CA MUTCD 2026 Figure Markups (Draft)

This "Figure Comparisons" document has been prepared by Caltrans to share the changes that are reflected in CA MUTCD 2026 initial draft version figures, when compared to National MUTCD 2023 figures, as well as current CA MUTCD 2014 Revision 8 figures (which were based on National MUTCD 2009). This document identifies California specific figures that are incorporated into CA MUTCD 2026 initial draft version and figures that are not incorporated and provides brief explanation, if they aren't incorporated. This document is being provided for ease in comparison, when reviewing CA MUTCD 2026 initial draft.

Figure 7B-5. Example of Signing for a School Zone with Higher Fines for All Traffic Violations (Sheet 1 of 2)

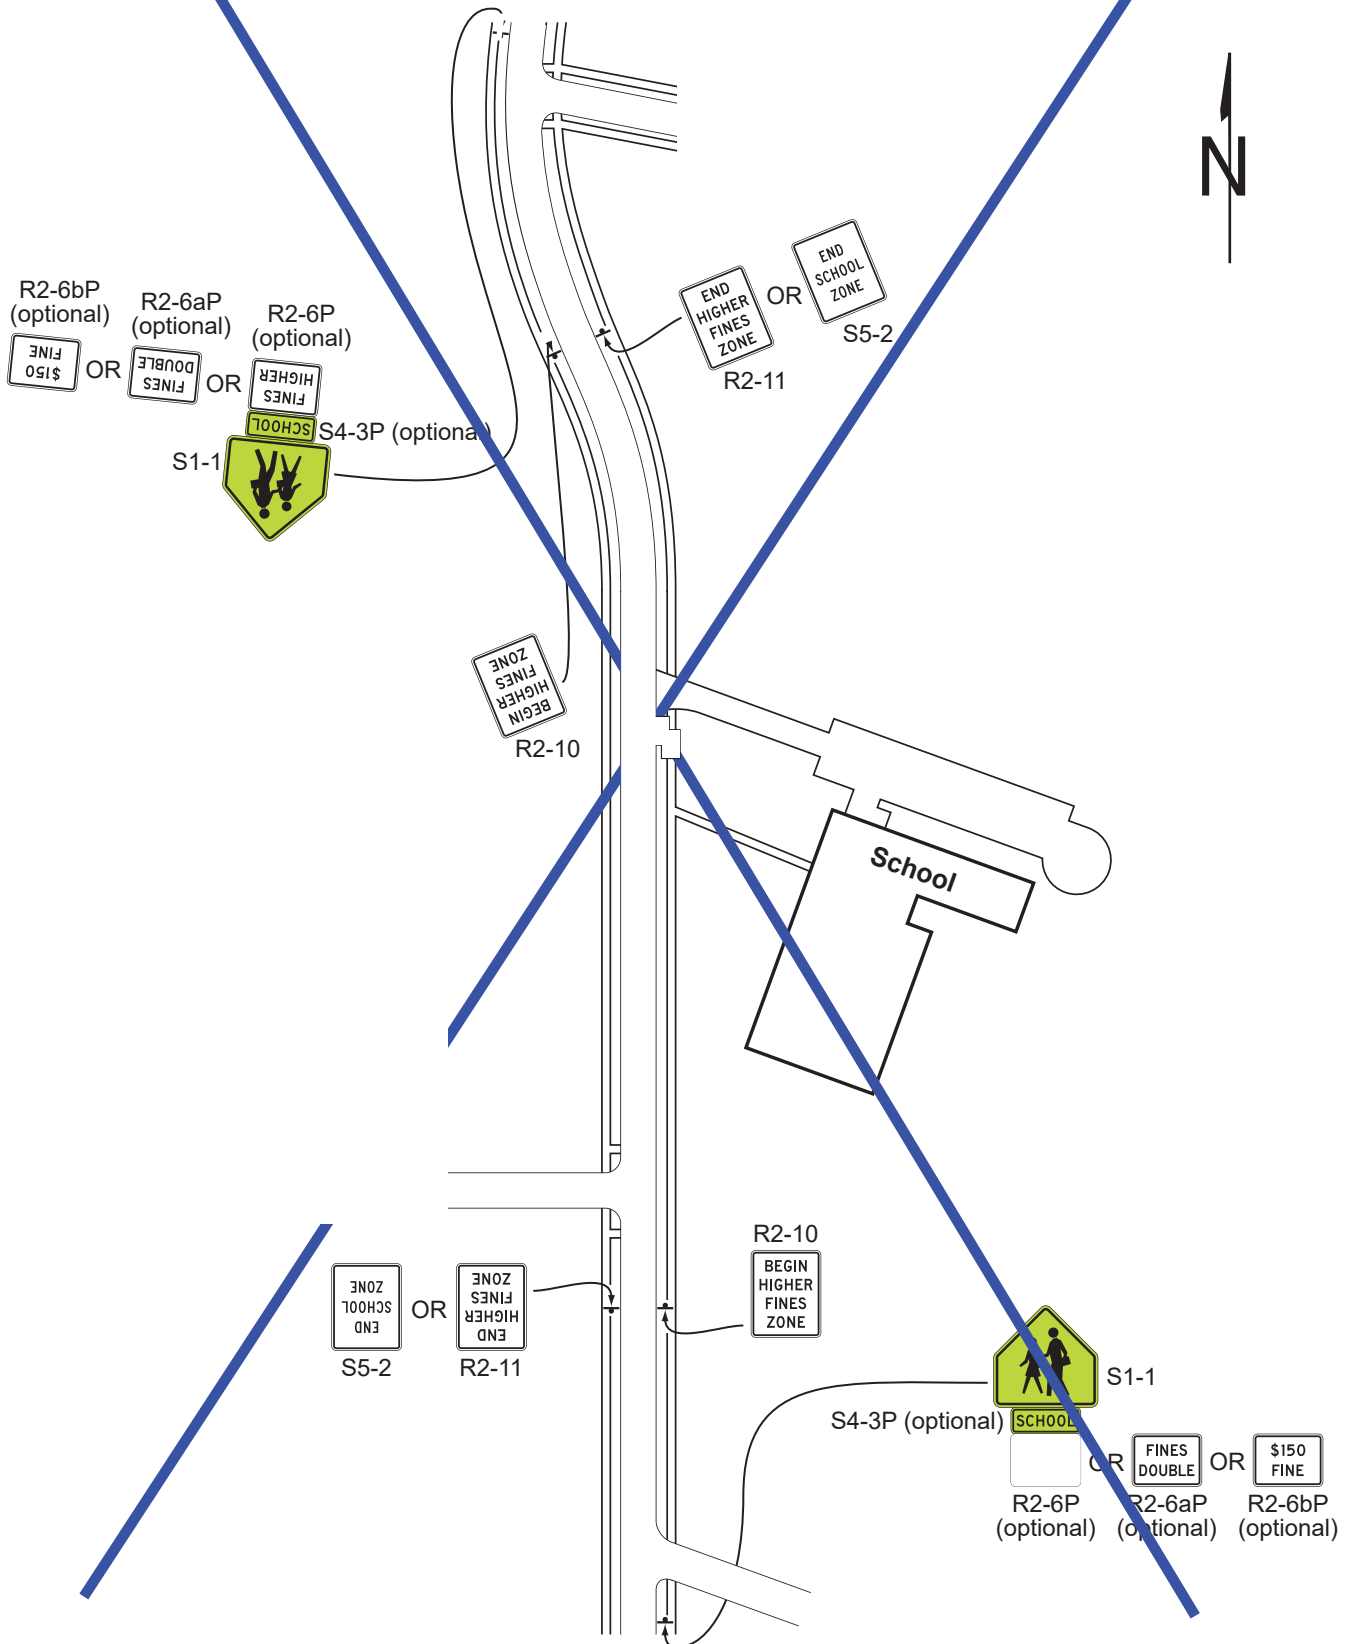
NMUTCD 2023 changed NMUTCD 2009 Figure number 7B-2 to 7B-5 (Sheets 1 and 2 of 2) and made other minor changes in the figure. NMUTCD 2023 Figure 7B-5(Sheet 1 of 2) is shown in CA MUTCD 2026 with a blue "X"

Since this figure is not applicable in CA, specific changes made in NMUTCD 2023 have not been identified.

Figure 7B-5. Example of Signing for a School Zone with Higher Fines for All Traffic Violations (Sheet 2 of 2)

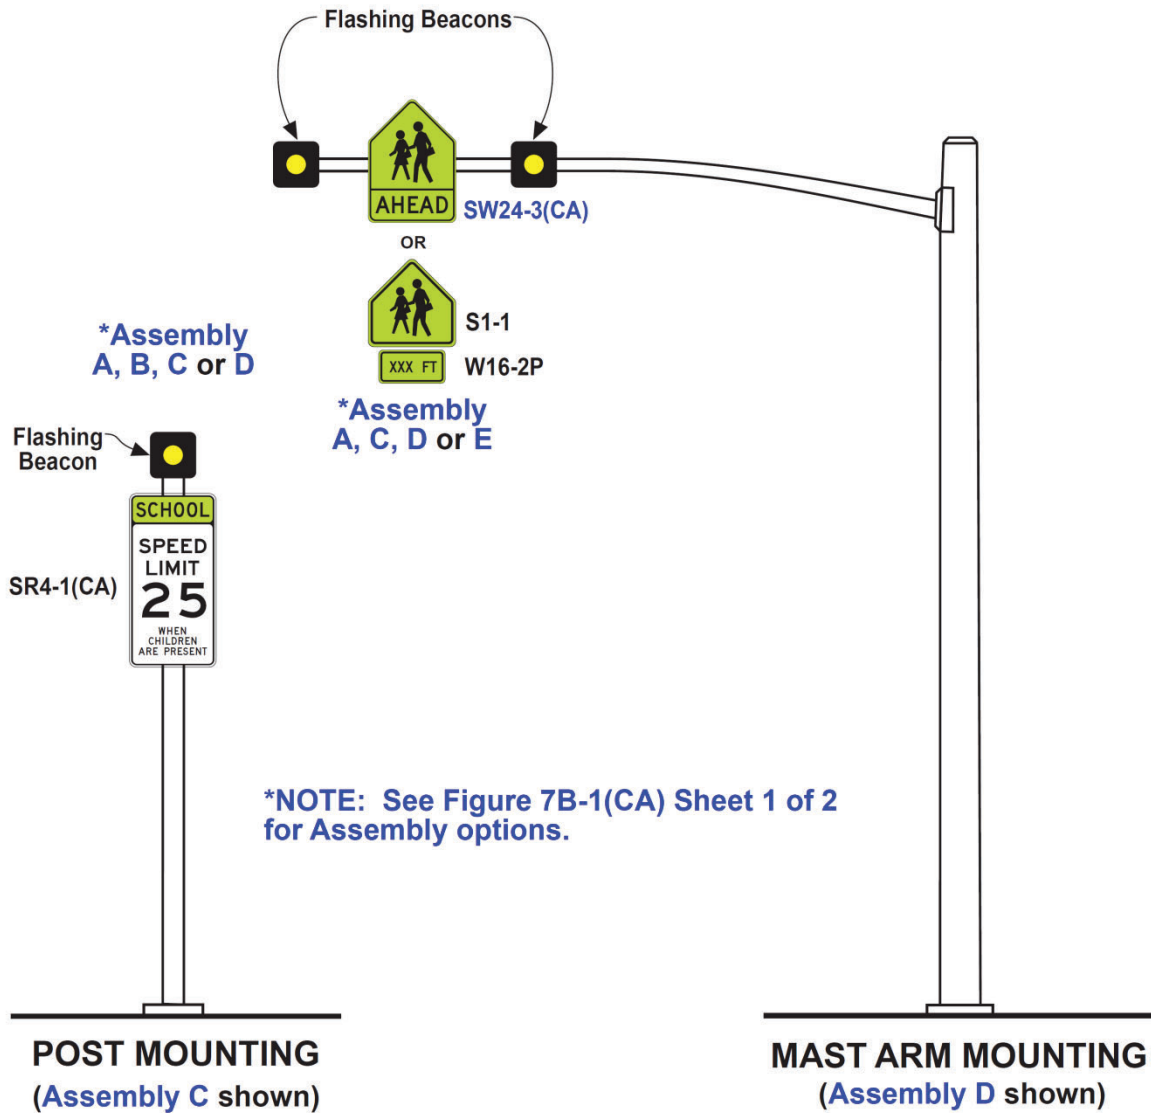
NMUTCD 2023 changed NMUTCD 2009 Figure number 7B-2 to 7B-5 (Sheet 1 and 2 of 2) and made other minor changes in the figure. NMUTCD 2023 Figure 7B-5(Sheet 2 of 2) is shown in CA MUTCD 2026 with a blue "X"

Since this figure is not applicable in CA, specific changes made in NMUTCD 2023 have not been identified.
